- 15. St. Luke Lutheran Church Replat; KPB File 2023-118
Segesser Surveys / St. Luke Lutheran Church of the
Unaltered Augsburg Confession
Location: Kenai Spur Highway
Salamatof Area / Nikiski APC**

St Luke Lutheran Church Replat

**ITEM #11 - PRELIMINARY PLAT
ST LUKE LUTHERAN CHURCH REPLAT**

STAFF REPORT

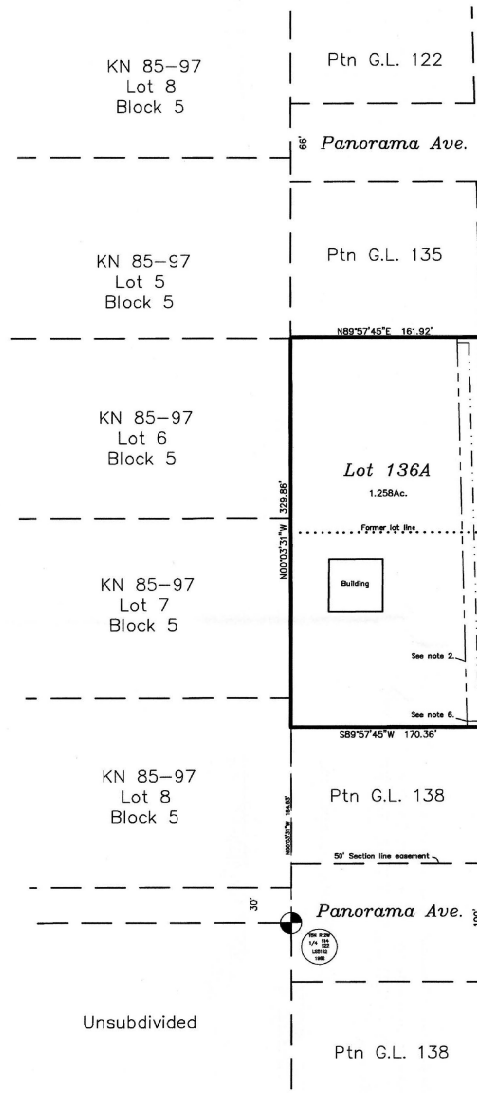
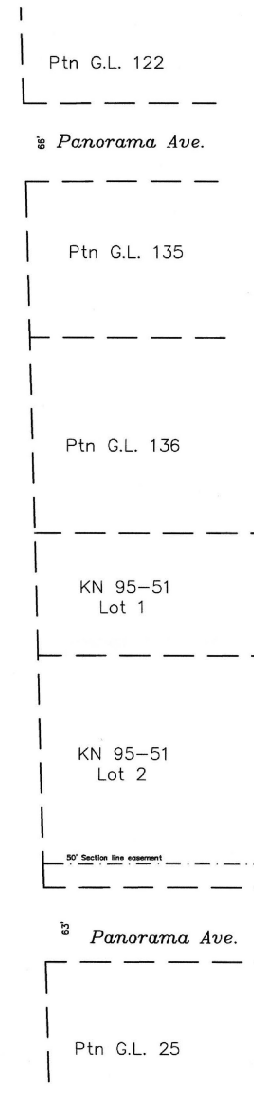
There are no classified wetlands within the boundary of the subdivision; however this area is in a mapped flood hazard area. ***Staff recommends: plat notes be added for floodplain and floodway.***

| HEA | Locate and depict the overhead three phase electric line. Provide a label or plat note stating, "The existing overhead powerline is the centerline of 40 ft. wide electrical distribution line, including guys and anchors, granted this plat." |

- Add KPB No 2023-118 to title block.

- All side roads need correct names listed for them except Panorama Ave to the south.

- Parcel to the south needs correct label.
- Parcel to the northwest needs correct label.

- Dimension from southwest corner down to GLO monument needs to be adjusted to match the size of the other dimensions on the drawing.

- Add meeting date of November 13, 2023 to Plat Approval
- On the Certificate of Ownership and Dedication, Correct the spelling of Seth Tauriainen and add President/Director behind his name.
